PROFESSIONAL SERIES (PRO-Z 100, 500, 700, 900 & PRO-X 600)

Date: April 20, 2021 Revised March 31, 2022 (Please Destroy All Previous Copies).

Subject: Intermittent Start Issue On Kawasaki FX Model Engines.

FIX-AS-FAIL

FIGURE 2

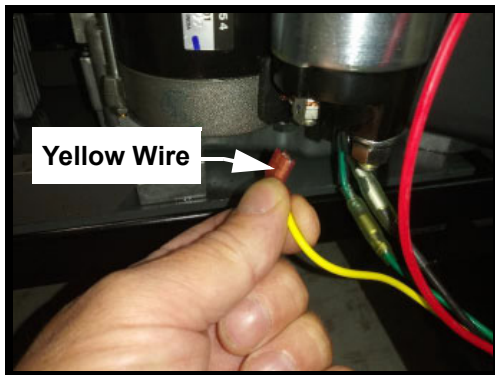
3. Park the rider on a flat level surface and engage the parking brake.
4. Disconnect the negative battery cable from the negative battery terminal.
5. Make sure the battery is fully charged. Place the battery on charge if needed.
6. Locate and disconnect the yellow engine wire harness (i.e. Kawasaki harness) wire from the solenoid. See Figure 2.

FIGURE 3

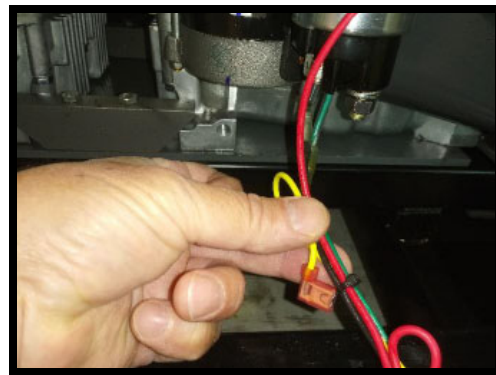
7. Zip tie or use electrical tape to secure the yellow wire to the engine harness as shown in Figure 3. This wire will no longer be used and will not be connected anything once the jumper is installed.
8. Locate the **725P15145** Jumper Harness with Relay shown in Figure 4.

FIGURE 5

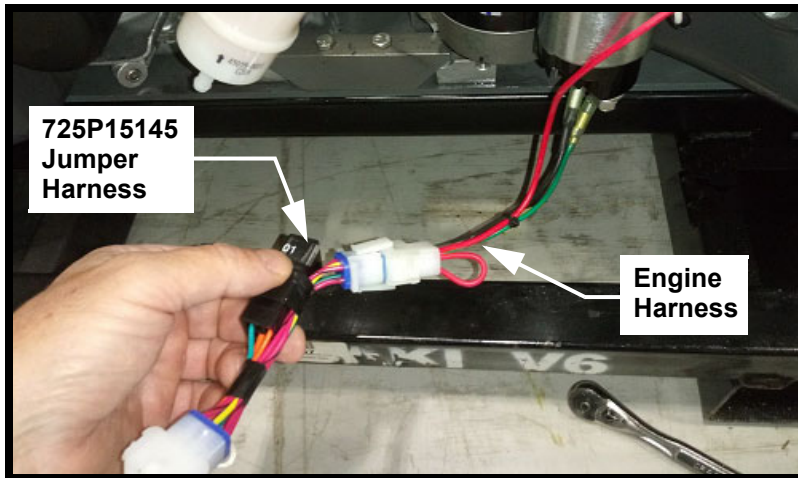
9. Disconnect the engine harness from the main wire harness.
10. Connect the **725P15145** Jumper Harness (Engine Connection) to the engine harness as shown in Figure 5.

FIGURE 6

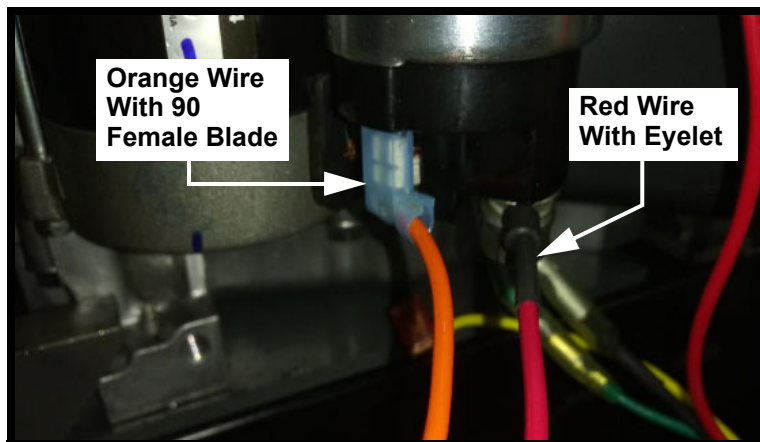
11. Connect the **725P15145** Jumper Harness (harness connection) to the riders main harness.
12. Connect the orange wire of the **725P15145** with the 90 degree female blade to the solenoid terminal where the yellow wire from Step 6 was removed. See Figure 6.
13. Remove the nut and lock washer from the positive post of the starter solenoid.
14. Connect the red wire with eyelet of the **725P15145** to the positive post of the solenoid and secure with the nut and lock washer removed in Step 13. See Figure 6

FIGURE 7

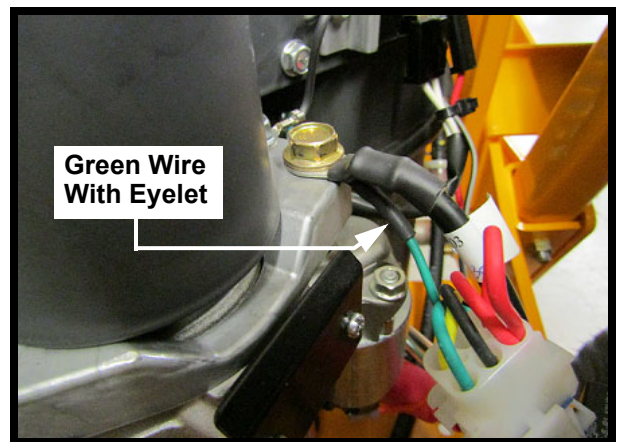
15. Remove the M8 x 1 hex head bolt that secures the main harness ground wire. Connect the green wire with eyelet to the engine in the same location the main harness ground wire is attached. Secure in place with the M8 x 1 hex head bolt. See Figure 7.
16. Securely tighten the nut in Step 14 and the M8 x 1 hex head bolt in Step 15.
17. Bundle the **725P15145** as shown in Figure 8 and zip tie or use electrical tape to secure to the starter solenoid to prevent water from entering the relay.
